Response to Section 92 Request: Consent Application RM21.668 – Mt Cooee Landfill, Balclutha

Thank you for the Section 92 further information request we received on 27 July 2024 in relation to Clutha District Council's resource consent application RM21.668 to renew resource consents associated with the Mt Cooee Landfill in Balclutha.

Schedule 1: Water Quality Sampling Locations

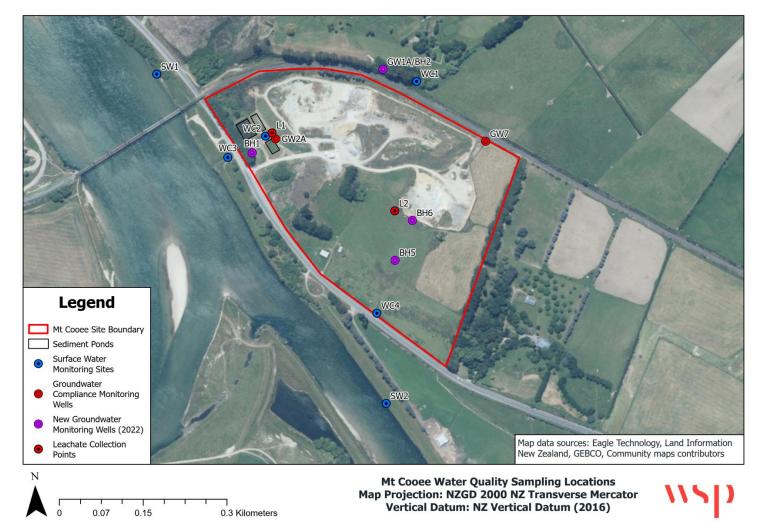
3. Please provide an updated Compliance Monitoring Schedule that clearly and unambiguously describes all ground and surface water (stormwater, Clutha River/Mata-au, onsite waterbodies, wetland) monitoring that is proposed for the duration of the consents, including parameters to be measured, monitoring locations, sampling frequencies, identifies any additional monitoring sites that will be established, and explains why the proposed monitoring is appropriate to ensure that adverse effects are identified and addressed. The Compliance Monitoring Schedule should also set out the specific trigger levels for each contaminant that will be relied upon in the Trigger Action Response Plan.

The following draft consent conditions, coupled with the attached Monitoring Schedule (Schedule 1 and 2), are presented to identify and address the potential adverse effects of the activity.

- 1. The sampling required by this consent shall be undertaken at the locations identified in the sampling locations map in Schedule 1. Parameters required for monitoring and their sampling intervals are provided in Schedule 2.
- 2. The monitoring required by this consent may be amended after consultation between the consent holder and the Otago Regional Council, and written confirmation by the Otago Regional Council of approval of any changes. The Otago Regional Council reserves the right to re-instate the monitoring required by this consent if there is an effects-based reason to do so.
